DESCRIPTIVE REPORT

Field No. PA-1357 Office No. H-8400

Locality President Channel

HYDROGRAPHIC SURVEY REVIEW

SECTION CHART 6380
9th Ed. Aug. 8, 1960
data in red from H-8400

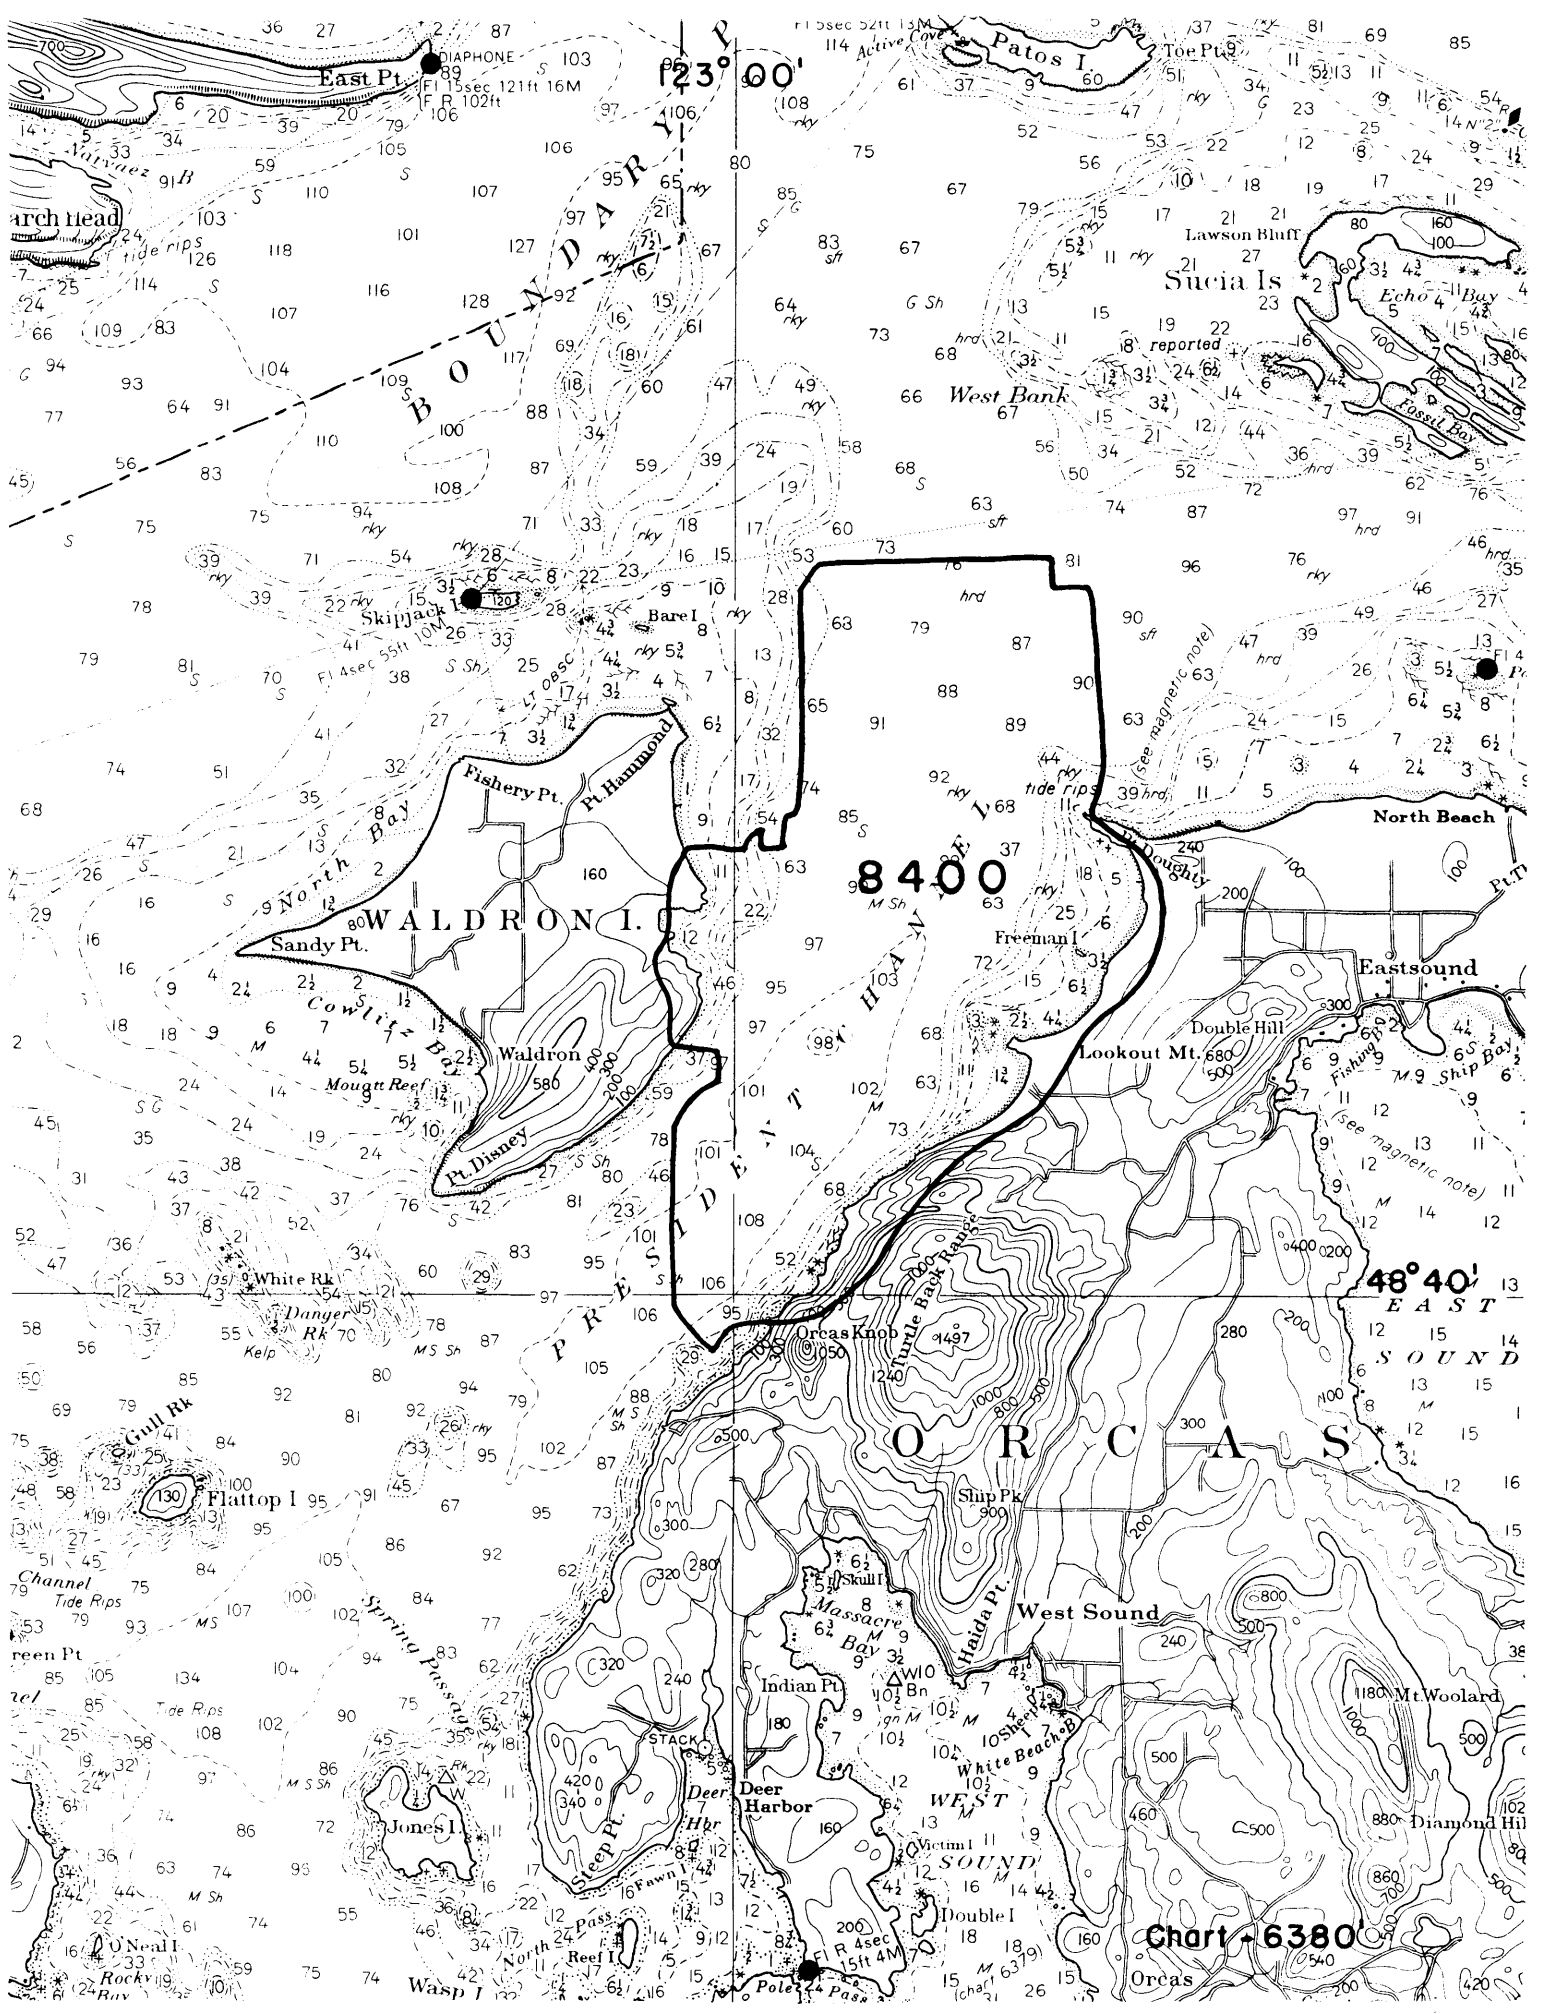
This survey has been compared with Chart 6380, 9th Ed., 8 August 1960. Every sounding on the Chart, in the area covered by the smooth sheet, has been compared. See section of chart attached to this report for comparison.
